ARCHITECTURAL REVIEW BOARD MEETING

Thursday, July 25, 2024 at 6:30 PM

STAFF REPORT

Meeting Date:	July 25, 2024
Agenda Title:	COA 24-35 40 S. Sixth Street
Requested Action:	Review request for the construction of an enclosed one-story porch on the rear elevation; alteration of the existing window fenestration of the side elevation as part of an interior kitchen remodel, to include installation of exhaust vents on same elevation.
Department / Agency Lead:	Community Development
Staff Lead:	Casey Squyres, Historic Preservation Planner

6 3D RENDERS
A1 Scale: not to scale

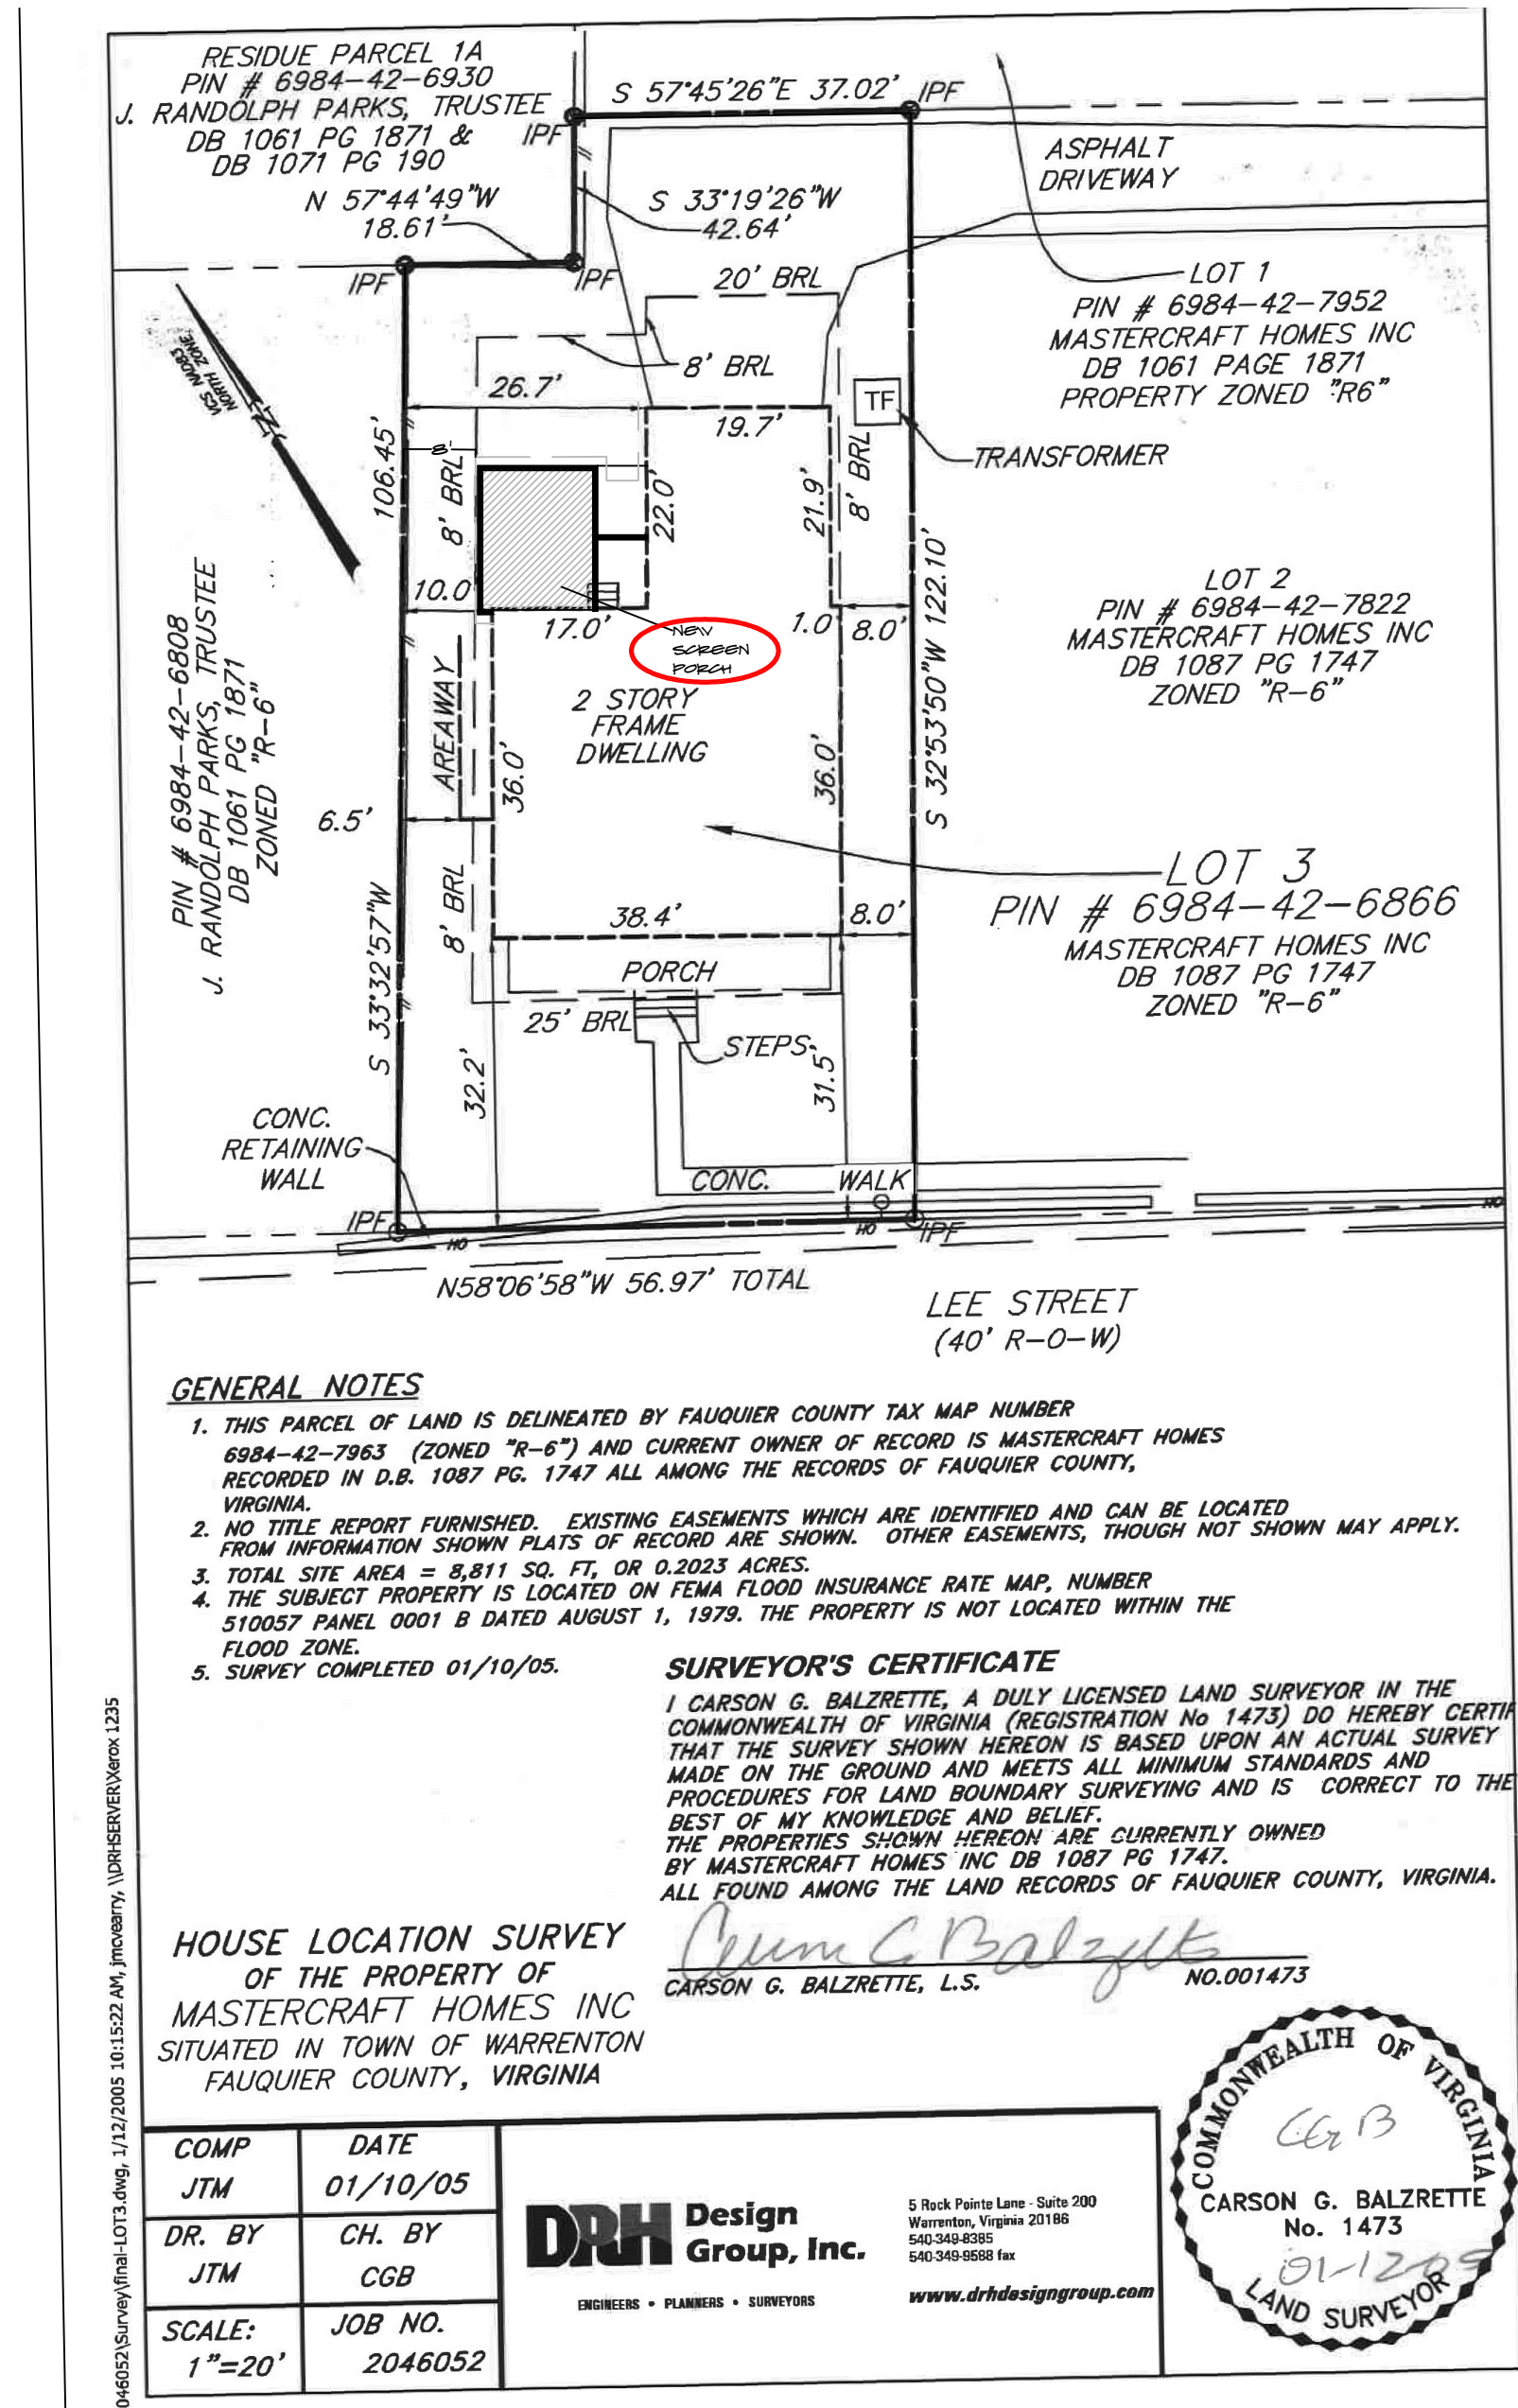
- 3) Proposed porch at 40 S. Sixth Street will be 14' x 14', one-story, shed roof clad in asphalt shingles to match the existing main roof. Siding for the porch will be clad in Hardie Plank siding to match the existing house.

- 4) A small stoop with two steps and iron railing (to match existing iron railing leading to basement) will be installed at the door to the enclosed porch.

- 1) All necessary permits are acquired.
- 2) The ARB suggests that the Applicant consider brick masonry for the new stoop off of the porch to match the existing masonry leading to the basement.

Revised porch window and railing design:

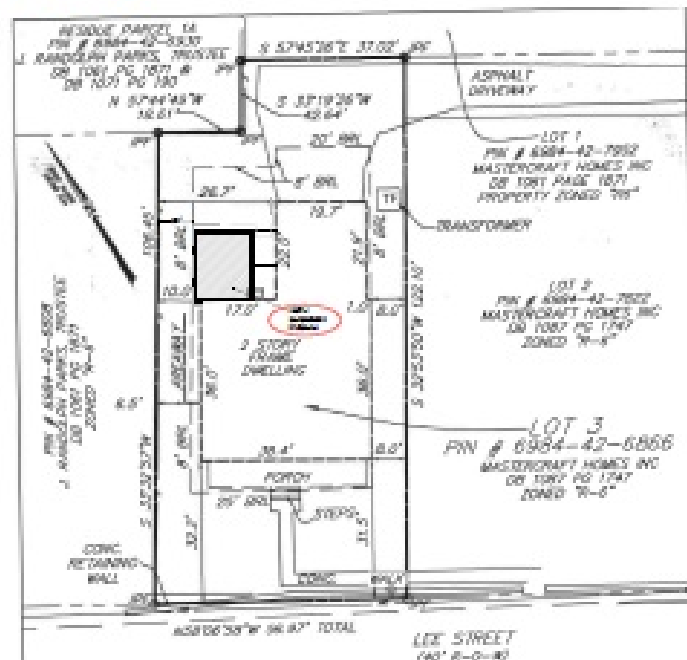
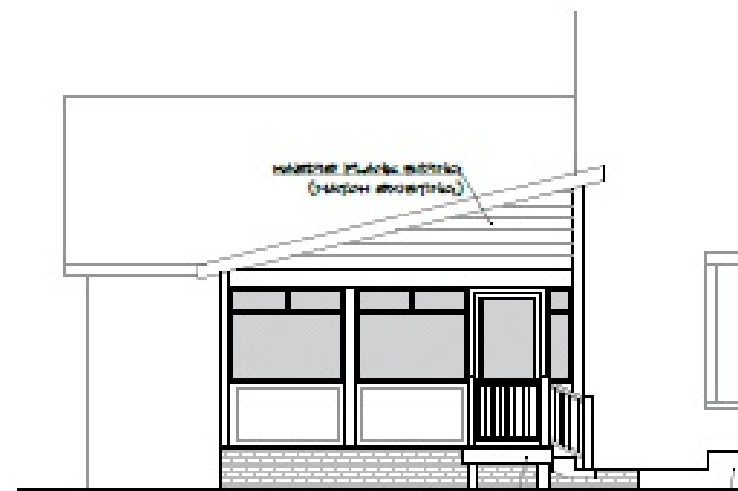
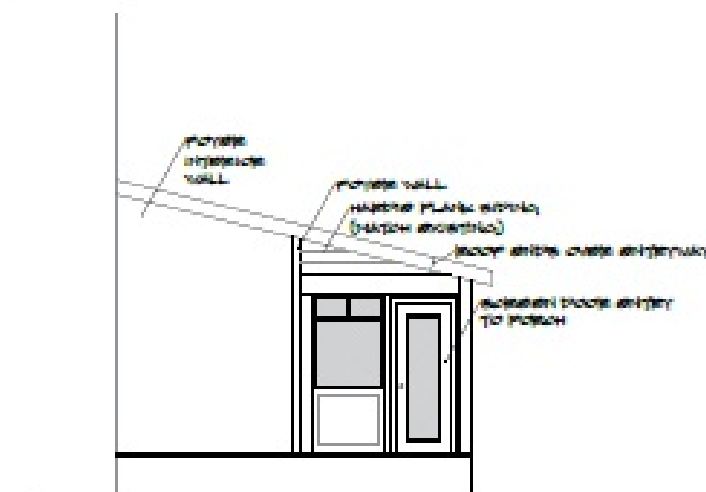
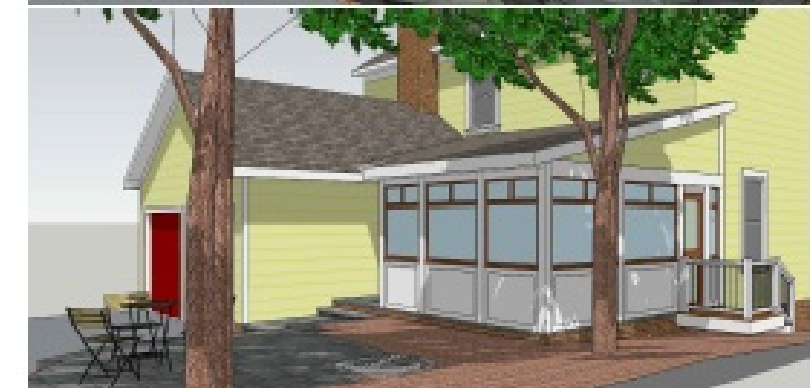
Railing to be iron railing to match existing basement railing.

PROPOSED FRONT ELEVATION, OPTION 01

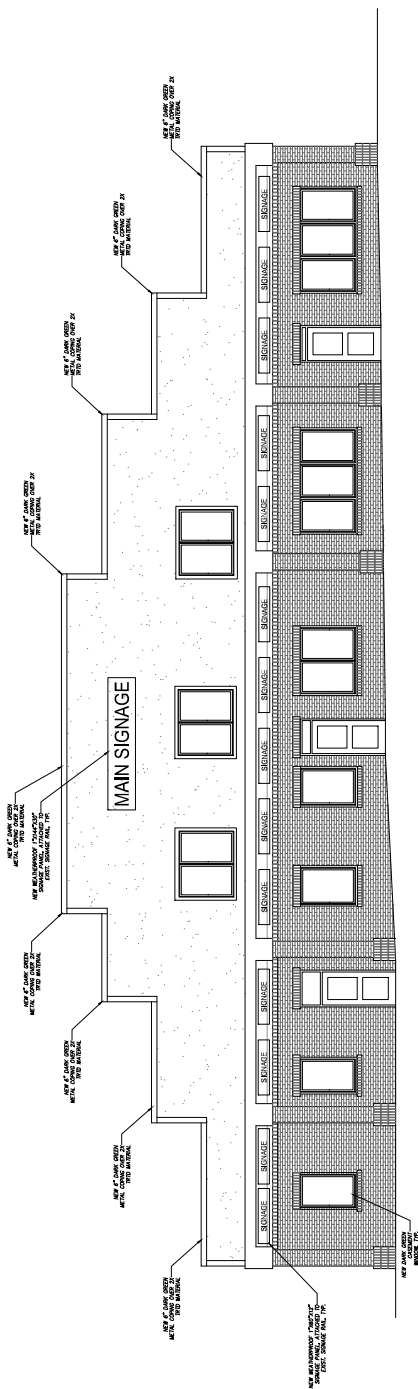
The Applicant is requesting approval to replace the existing wooden windows (which were installed sometime between 1980-early 2000s) due to inefficiency and water infiltration. The Applicant is requesting to replace with wooden, aluminum-clad Harvey windows, to include the alteration of the existing tri-part windows with picture windows, as shown in the ca. 1970 image provided by the Applicant.

- 1) All necessary permits are acquired.
- 2) Retain fenestration patterning, size, shape, and operation. Owners of buildings with windows and doors that have been altered in the past are encouraged to restore these elements to their original appearance based on site evidence and appropriate historic research.
- 3) Design new windows, doors, and other elements to be compatible with the original building
- 4) Possible condition of approval to consider: All new windows shall be wood windows to match the existing, and not aluminum-clad wood windows, as proposed.
